LOST CREEK ISR, LLC

**Re: Lost Creek Project Responses to Health Physics Comments
Docket No. 40-9068
TAC No. LU0142**

NRC and Lost Creek ISR, LLC's Detailed Discussion Summary

FIGURE 2.5-5
PASSIVE RADIOLOGICAL SAMPLING LOCATIONS

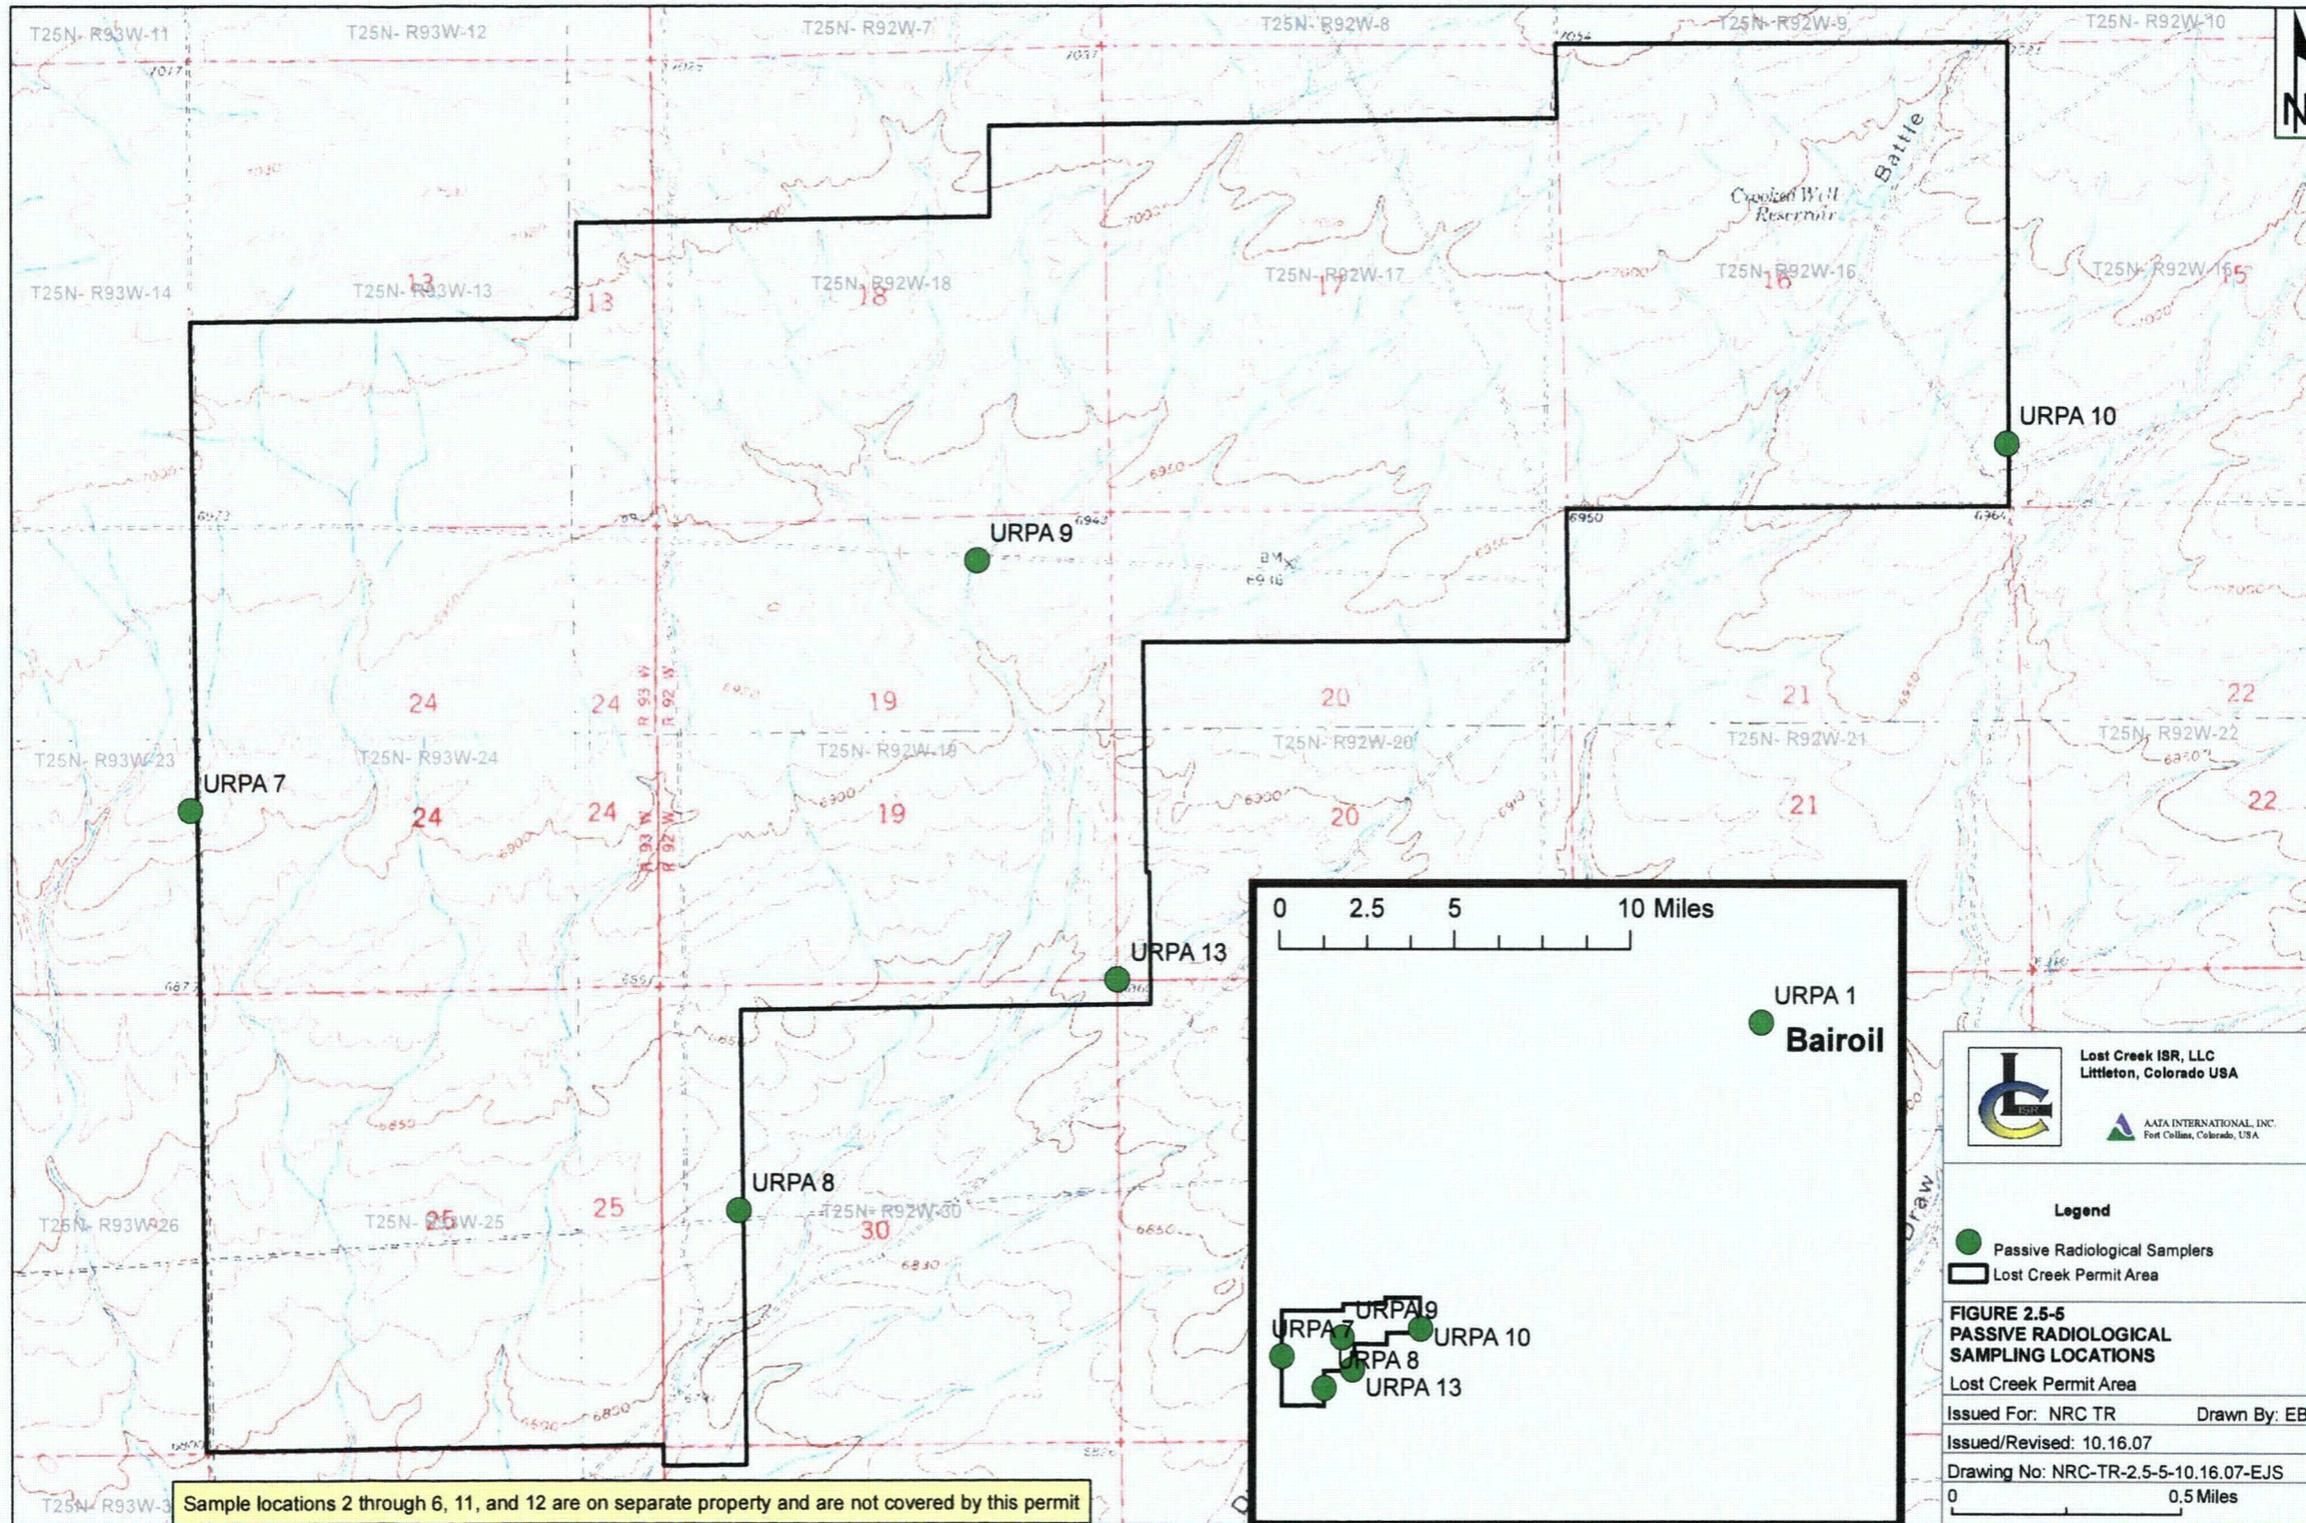
Co-Located Samples. Radon and gamma passive samplers were installed beginning in November 2006 (Attachment 3). At that time, the Plant Site had not been determined. Sampling locations were selected to represent: the center of the Permit Area (URPA-9); the upwind (URPA-7) and downwind (URPA-10) locations (based on site knowledge and available meteorological data); the southern Project Area boundary (URPA-8), which is closest to the Sweetwater Mill; and the closest residence (URPA-1). In February 2007, an additional sampling location (URPA-13) was added in response to the expansion of the proposed Permit Area.

In agreement with RG 4.14, LCI will monitor radon gas and direct radiation, at the same locations as in the preoperational monitoring (Attachment 3) plus at those additional operational locations described in LCI TR Section 5.7.7 (Attachment 4). Additionally, radon gas and direct radiation measurement will also be co-located with the background HV-3 particulate air monitor, and monitors HV-2 and HV-5 (Attachment 2). HV-2 is currently located within the location of the plant, so practically it must be relocated slightly and will be repositioned just outside the fence line nearest the MILDOS maximum point discussed above. There will then be a total of eleven locations with radon gas and direct radiation measurement; five of which will be co-located with the particulate air monitors.
